STAFF REPORT: 09/10/2025 MEETING

ADDRESS: 2491 LONGFELLOW

APPLICATION NO: HDC2025-00446

SCOPE: REPLACE FRONT PORCH COLUMNS, REPLACE WINDOWS, INSTALL LANDSCAPING (WORK COMPLETED WITHOUT APPROVAL), INSTALL PATIO AT REAR YARD

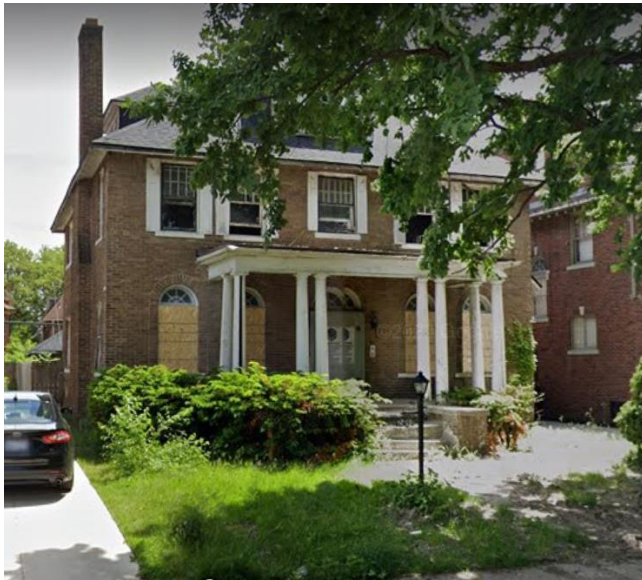
- As noted above, the wood windows and brickmould/trim which were removed without HDC approval were distinctive, character-defining features of the house. Per the Standards, if the windows were in poor condition, they should have been retained and repaired. As the current application does not provide evidence that the original windows were deteriorated beyond repair, their removal does not meet the Standards.

- Also, the Standards require that distinctive, character-defining features of a property be matched in-kind if they must be replaced in order to maintain a property's historic character. It is HDC staff's opinion that the current windows and associated trim fall well short of that requirement. Rather, the new windows and trim diminish the building's association with Colonial Revival style. Specific issues/areas in which the new windows and trim do not adequately match the original elements include the following:

- The lite configuration of the existing vinyl operational units does not match the historic throughout
 - The lite configuration/the radial pattern and opacity of the historic transoms at the front facade has not been matched

- The operation of several units does not match the historic, to include the replacement of double hung windows with slider units at the front, rear, and side walls.

- The current consumer grade, vinyl windows and aluminum brickmould display a plasticity and flat/thick appearance that does not adequately match the profile/dimensionality and appearance of the historic windows. Also, the muntins between the glass provided a flattened appearance which is inconsistent with a true divided lite window.

- For the above-listed reasons, Staff recommends that the Commission deny the submitted window proposal.
- With respect to the proposal to retain the existing wood columns at the front porch, staff notes that the round wood columns which were removed without HDC approval were highly distinctive, character-defining features of the house. Per the Standards, if the columns were in poor condition, they should have been retained and repaired. As the current application does not provide evidence that the columns were deteriorated beyond repair, their removal does not meet the Standards. Also, the Standards require that distinctive, character-defining features of

Site plan, indicating the location of the proposed patio (labeled “pavers”). Provided by applicant.

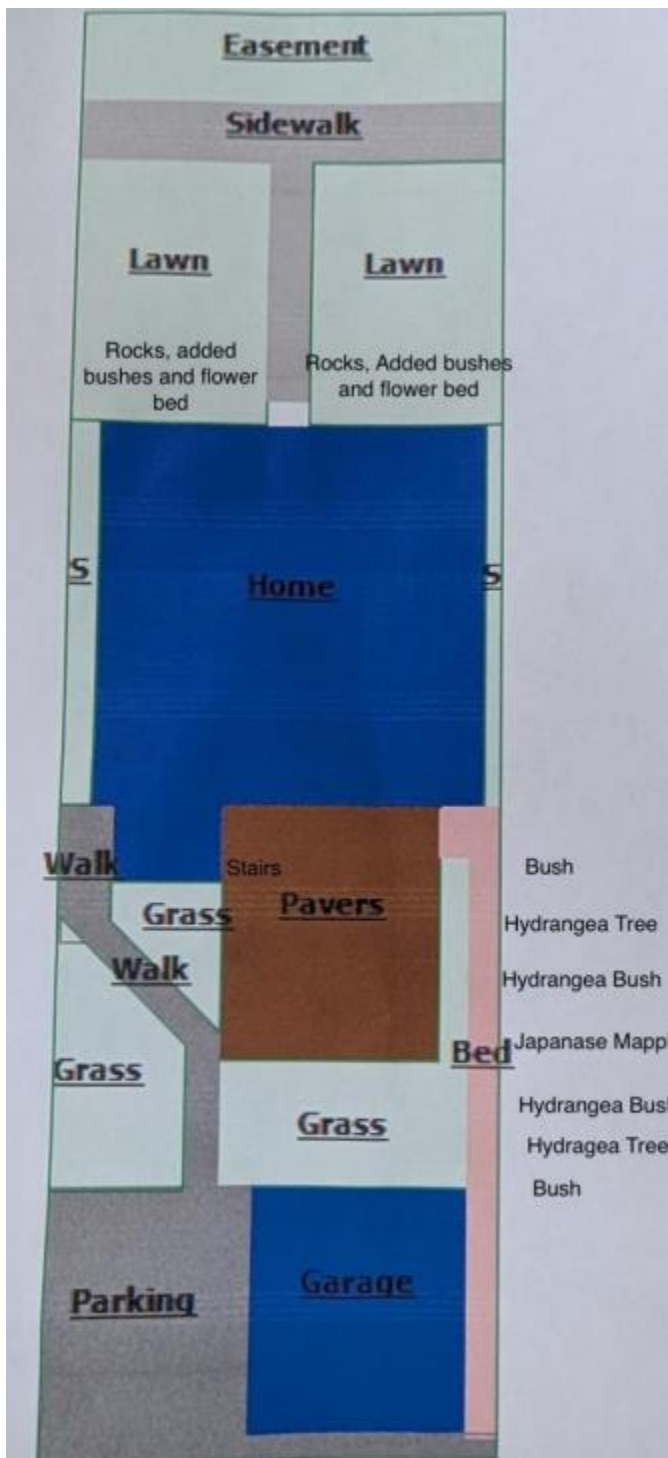
- Staff supports the addition of a patio to the rear yard and new steps which will lead from the existing non-historic rear porch to the new patio. The applicant has noted that the patio will be 300 square feet. However, the submitted site plan does not provide overall dimensions of the backyard, existing buildings, and/or the existing hardscape so the scale of the patio relative to these elements is unknown (see the below). Also, the final material for the patio has not been identified. Finally, note that dimensioned drawings of the proposed stairs (in plan and elevation) which will lead from the porch to the patio have not been provided. Staff recommends approval of these items with the condition that the applicant provide the following to staff for review and approval prior to the issuance of permit:

- The front door's leaded glass vision panel is incompatible with the building's historic character/Colonial Revival style
- The submitted site plan does not provide overall dimensions of the backyard, the existing buildings, and/or the existing hardscape so the scale of the proposed patio relative to these elements is unknown. Also, the final material for the patio has not been identified. Finally, dimensioned drawings of the stairs which will lead from the porch to the patio have not been provided.

- Site plan of the backyard which shows the footprint dimensions of all existing buildings, hardscape (walkways and parking pads), planting beds, and the proposed patio

- Drawing of the proposed steps in plan and elevation which indicates its materiality

- Site plan of the backyard which shows the footprint dimensions of all existing buildings, hardscape (walkways and parking pads), planting beds, and the proposed patio
- Drawing of the proposed steps in plan and elevation which indicates its material
